CITY OF BELOIT

REPORT TO THE BELOIT LANDMARKS COMMISSION

File Number: COA-2012-12

Location: 326 St. Lawrence Avenue

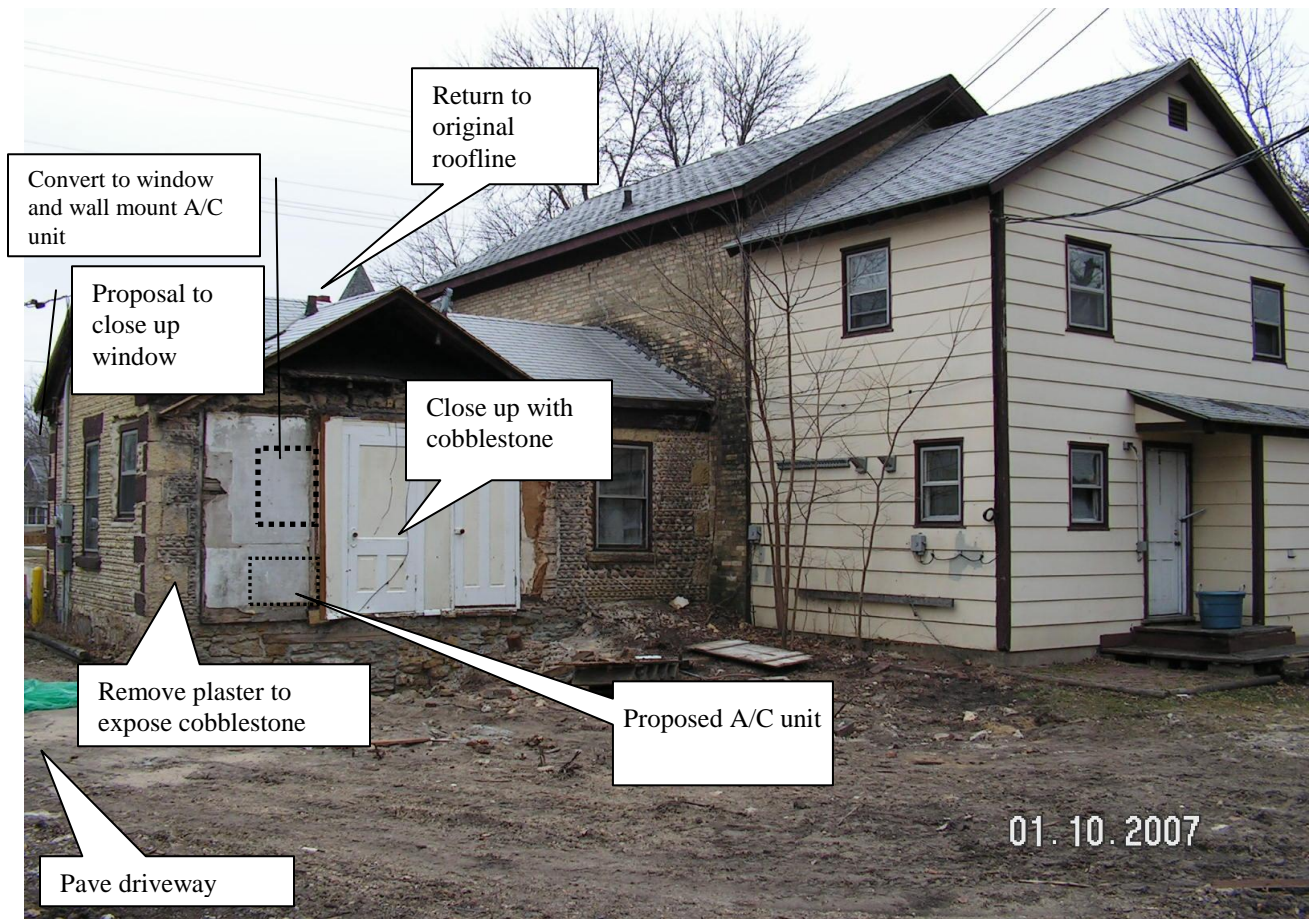
Tuckpoint
and remove
tar

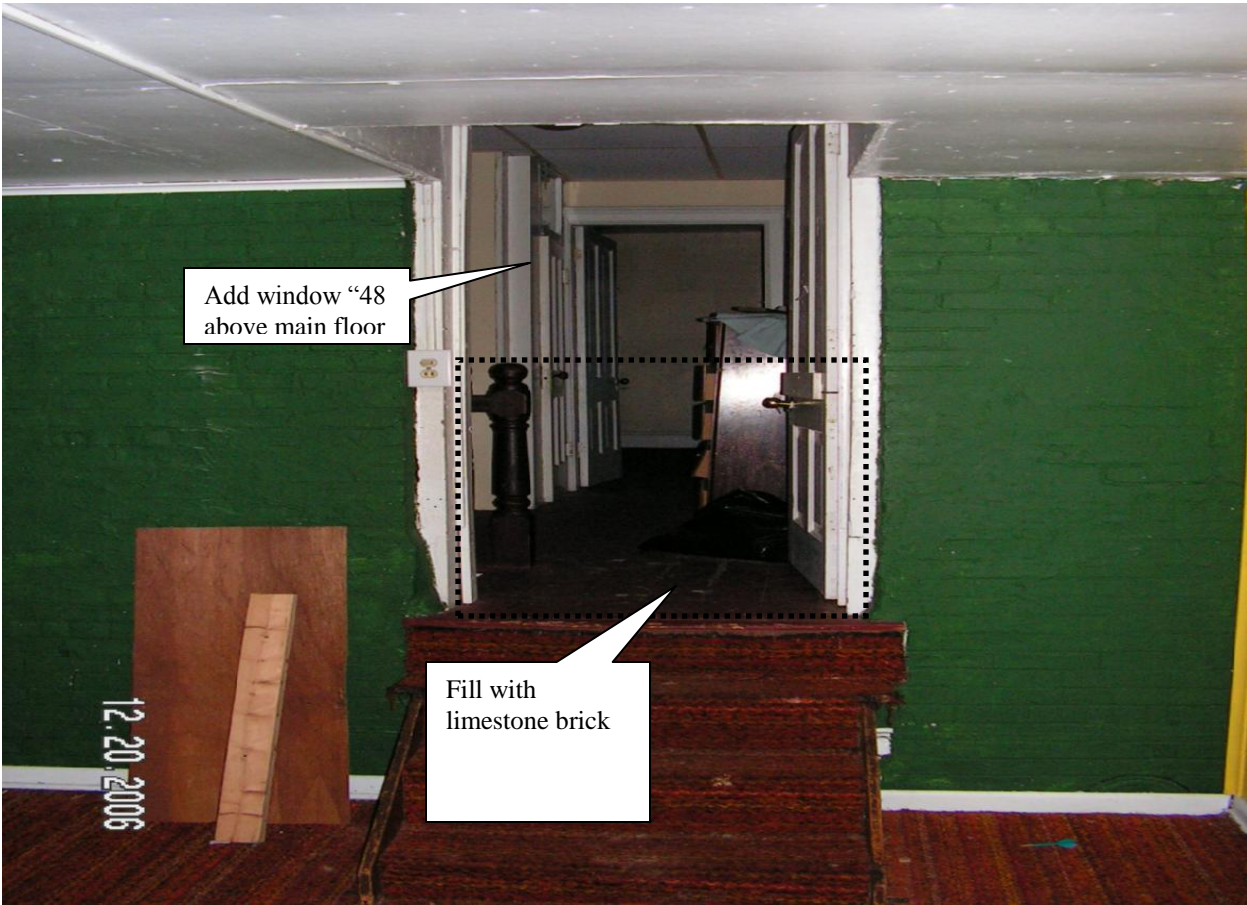
Replace
with
poured
concrete
patio

Proposed
shorter kitchen
window

Prior demolition
(safety threat)

Replace wood-
sided addition
with new
poured
concrete patio

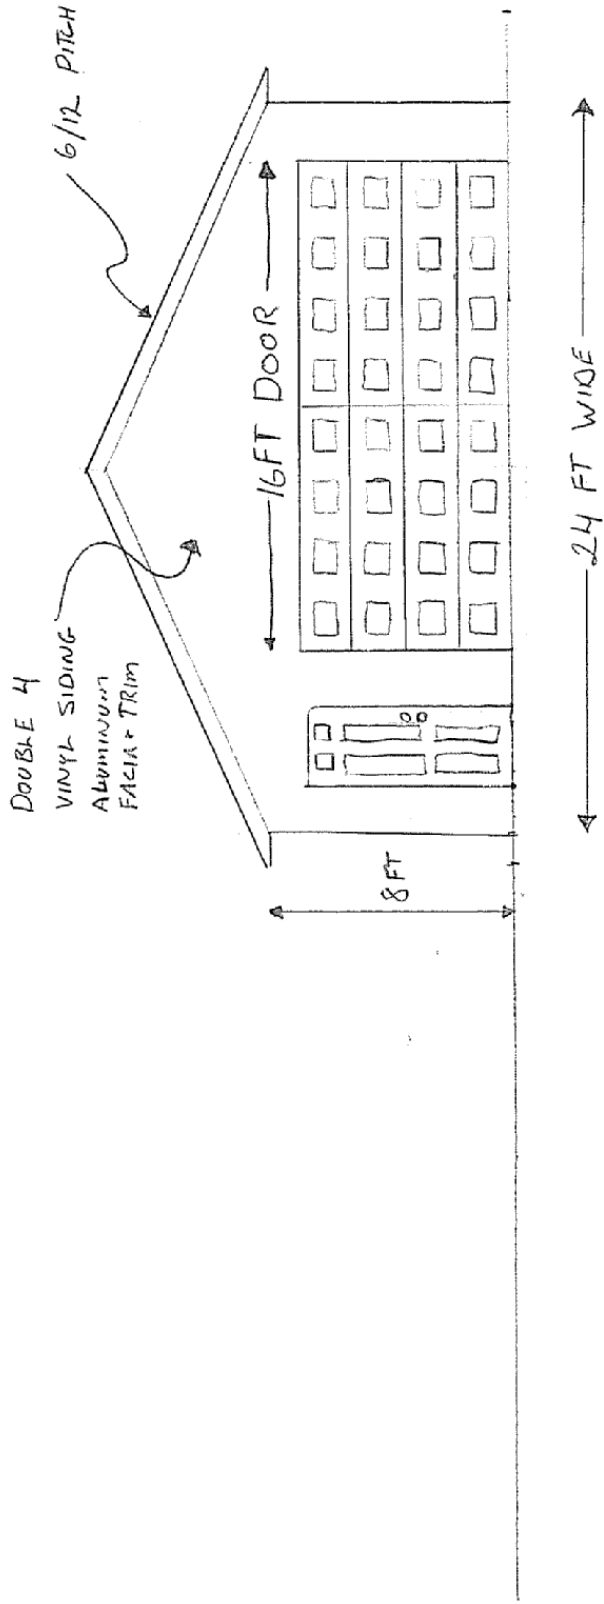
Feature to
remove

Remove tar
from brick
